Re: St Peters Terminal - additional atmospheric dispersion modelling - 1.75 Mtpa handling facility throughput - response to EPA letter

The NSW Department of Planning, Industry and Environment (DPIE) received technical review comments for the Modification 12 air quality impact assessment (MOD12 AQIA) from the NSW Environment Protection Agency (EPA) in a letter dated 24 July 2020 (the EPA letter). The recommendations from the EPA and associated responses are presented in the following sections.

Figure 2.1 Contribution to predicted additional cumulative 24-hour average PM_{2.5} concentration exceedance— receptor R4

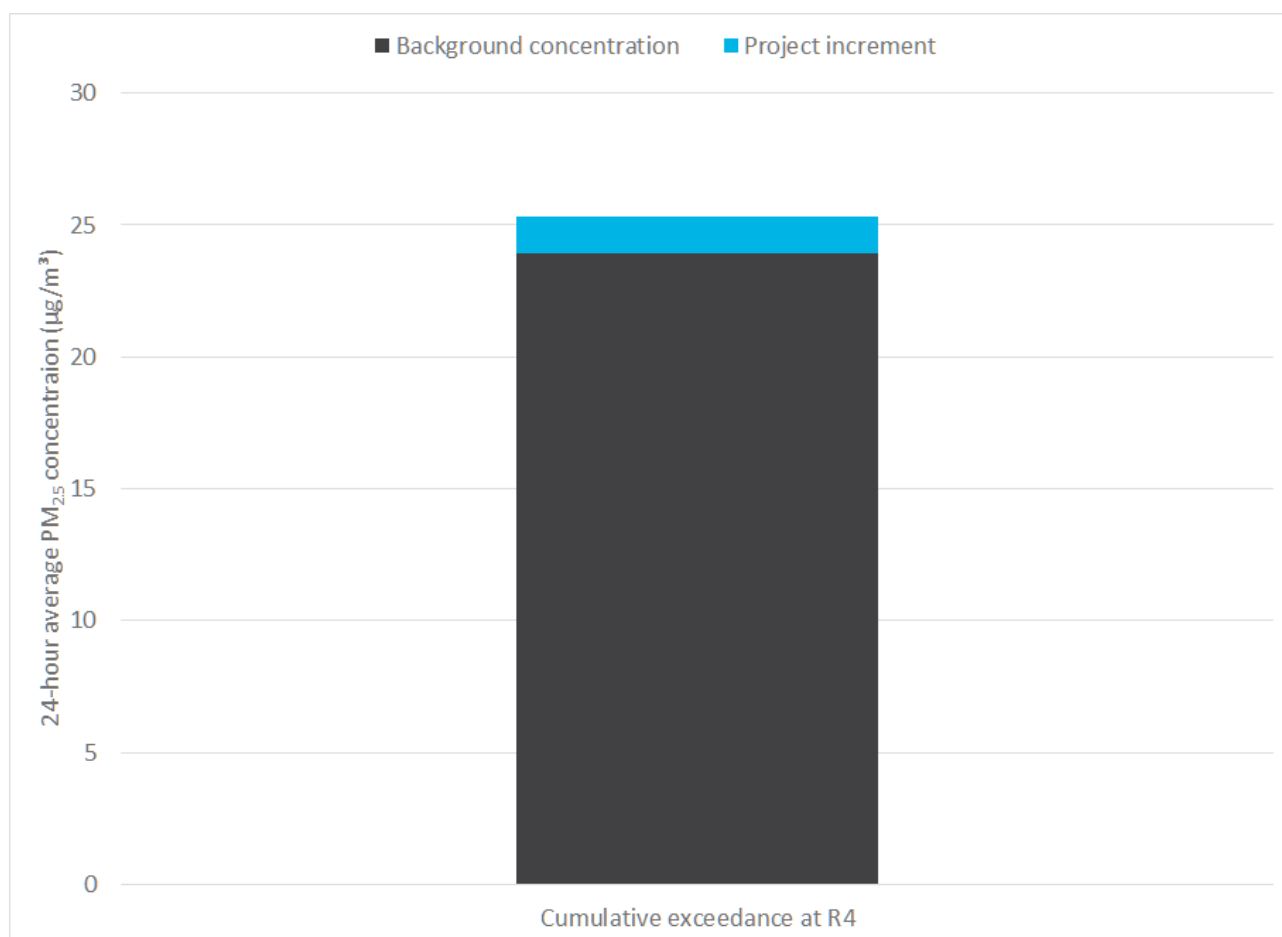
The additional AQIA does not clarify whether a contemporaneous assessment of particulate impacts was undertaken or whether the highest predicted incremental concentrations were added to the highest (non-exceedance) background concentration (2015 Earlwood).

On page 2 of the letter, the EPA has presented cumulative impact assessment calculations for receptor R3 (cumulative 24-hour average PM₁₀) and R4 (cumulative 24-hour average PM₁₀). The Earlwood 2015 PM₁₀ and PM_{2.5} monitoring datasets were used as background consistent with the MOD12 AQIA. There are one and two recorded concentrations above the applicable EPA impact assessment criteria for PM₁₀ and PM_{2.5} respectively in the Earlwood 2015 dataset.

Nevertheless, EMM can confirm that the MOD12 AQIA undertook a contemporaneous cumulative assessment approach, consistent with the Level 2 assessment approach detailed in Section 5.1 of the Approved Methods for Modelling (EPA 2016). As stated in the MOD12 AQIA, a single additional exceedance day was predicted at receptor R4 for 24-hour average PM_{2.5}. This exceedance coincided with a background concentration of 23.9 µg/m³. The contribution to the cumulative exceedance at R4 is illustrated in Figure 2.1.

It can be seen from Figure 2.1 that the background concentration dominates the cumulative concentration (approximately 94%). The other following points are noted:

- the modelling results relate to peak day activity rates occurring continuously throughout the modelling period, which is a highly conservative assumption;
- by adopting the maximum annual throughput at the handling facility, the modelled scenario relates to the worst-case potential for operational split with regards to air emissions and impacts.
- the impacted receptor in question is an industrial receptor that would not be exposed to an entire 24-hour averaging period.
